UNITED STATES PATENT AND TRADEMARK OFFICE

APPLICATION NO.	FILING DATE	FIRST NAMED INVENTOR	ATTORNEY DOCKET NO.	CONFIRMATION NO.
10/624,559	07/23/2003	Masaharu Nishikawa	50195-375	6633

Office Action Summary	Application No. 10/624,559	Applicant(s) NISHIKAWA, MASA HARU	
	Examiner Katherine W. Mitchell	Art Unit 3677

DETAILED ACTION

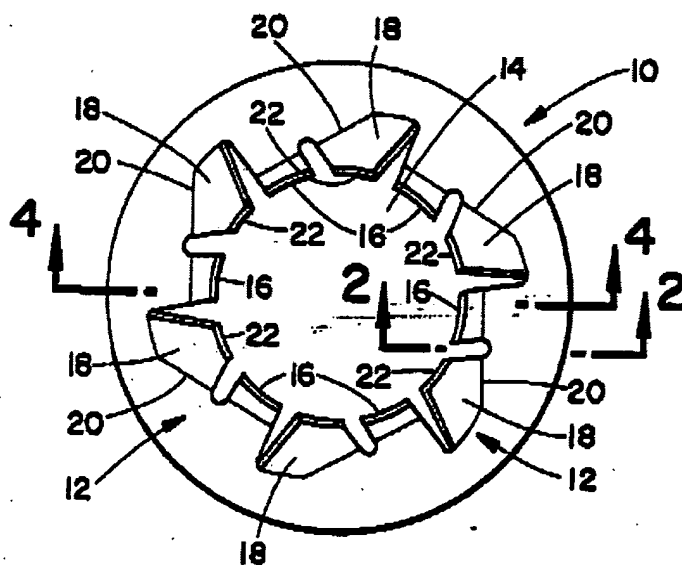
Re claims 1 and 7: Fisher discloses an attachment clip and structure for attaching a first member, having a hole, to a second member, having a projecting bolt passable through said hole, comprising:

- A clip body 12 with an abutment part capable of attaching a first member to a second member, having a shank hole to accommodate passage of a bolt
- A plurality of engagement claws (spring fingers 18 and 16 are both considered claws, per Fig 4 and col 3 lines 51- col 4 line 41) formed around inner periphery of hole and radially projecting inward (Fig 1) and inclined to the clip body so that

- Wherein the tips of two specific claws are apart from each other a predetermined distance in height (Fig 4, 18 higher than 16) and the height difference is equal to one or more thread pitches on the bolt shank.

Examiner notes that in addition to the figure above, col 4, lines 20-25 teach that the length of the tip 22 of claw 18 is at least as long or preferably longer than the distance between adjacent thread crests to ensure that the tips or terminal edges are in engagement with at least one thread crest. Thus the tip 22 of claw 18, which has been described as extending along a helical path, is separated from the tip of 16 by a distance equal to at least one or more thread pitches.
